Technical Service Bulletin

SUBJECT: MIL ILLUMINATION WITH DTC P0AA7/P0AA8		No: TSB-18-54-005
		DATE: July 2018
		MODEL: 2018 Outlander PHEV
CIRCULATE TO:	<input type="checkbox"/> GENERAL MANAGER	<input checked="" type="checkbox"/> PARTS MANAGER
<input checked="" type="checkbox"/> SERVICE ADVISOR	<input checked="" type="checkbox"/> SERVICE MANAGER	<input checked="" type="checkbox"/> TECHNICIAN
	<input checked="" type="checkbox"/> WARRANTY PROCESSOR	<input type="checkbox"/> SALES MANAGER

SUB-BMU REPROGRAMMING CHART

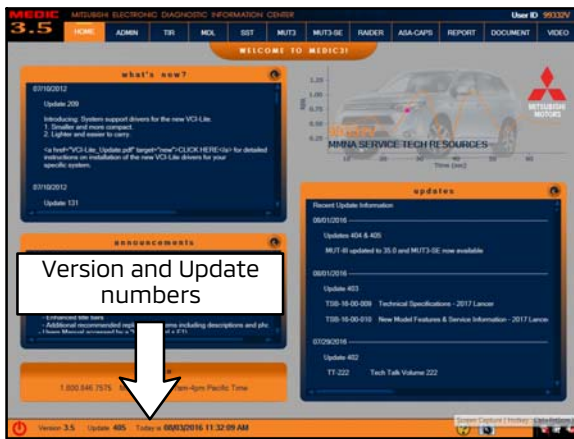
This condition may be caused by inappropriate programming of the sub-Battery Management Unit (sub-BMU). The sub-BMU may falsely judge the leak detection circuit as faulty by picking up electrical noises from operation of the drive selector, brake application, or air conditioner operation. This TSB instructs dealers to reprogram the sub-BMU with updated software to correct the issue.

1. Confirm your MUT-III is updated with the latest reprogramming database.
2. Reprogram the sub-BMU with the new software. Refer to the "Sub-BMU Reprogramming Chart" for new software information.

Sub-BMU Part Number		Data Number	Software Version	
			Previous	New
9479A057	Without Battery Heater	9479A167	BE3100	BE3101
9479A058	With Battery Heater	9479A168	BE3014	BE3015
